## **DX5 II Issue Log from Post #661 and Later**

Audio Science Review Thread:

### **Bluetooth Pairing Button - [LINK](#)**

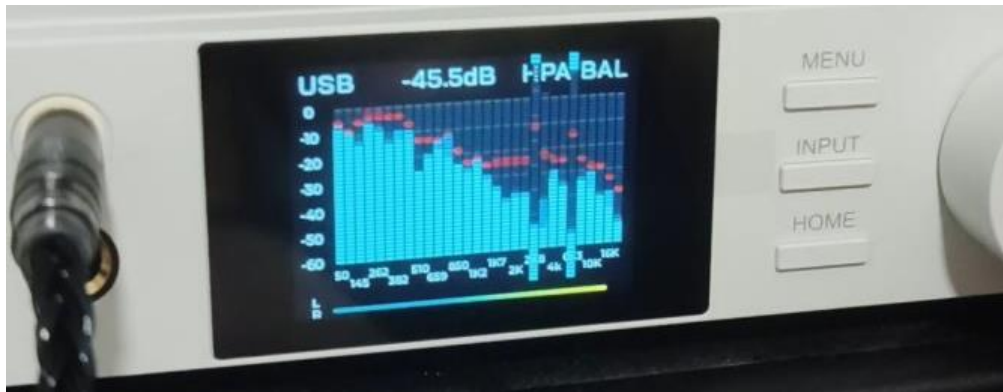
- 1) Bluetooth Pairing - Use the brightness button on the remote (knob press didn't work for me).

### Unit Runs Very Warm, No Venting, Consider adding Venting – [LINK](#)

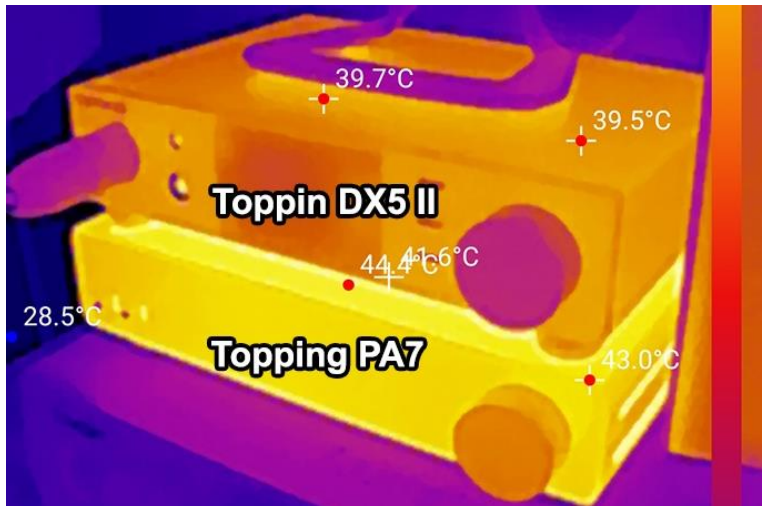
- 1) Also, it runs warm, no vents in the housing so that is interesting. *Consider adding vents.*

### Sub Menu, Shown in Aurora theme after some number of power cycles

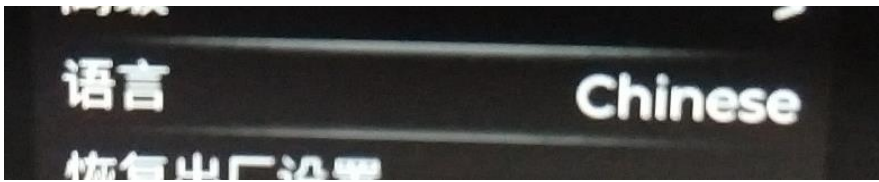
- 1) The sub-sub-menus in all color themes (Aurora properly shows Aurora) are shown in the Aurora theme after some number of power cycles or amount of time. [LINK](#)
- 2) I tried power cycling it yesterday up to 10 times and that did nothing, but when I turned it on the first time yesterday with the white theme as well as today with the blue theme, it was again the case. Power cycling the unit without changing the display settings does not fix it. [LINK](#)
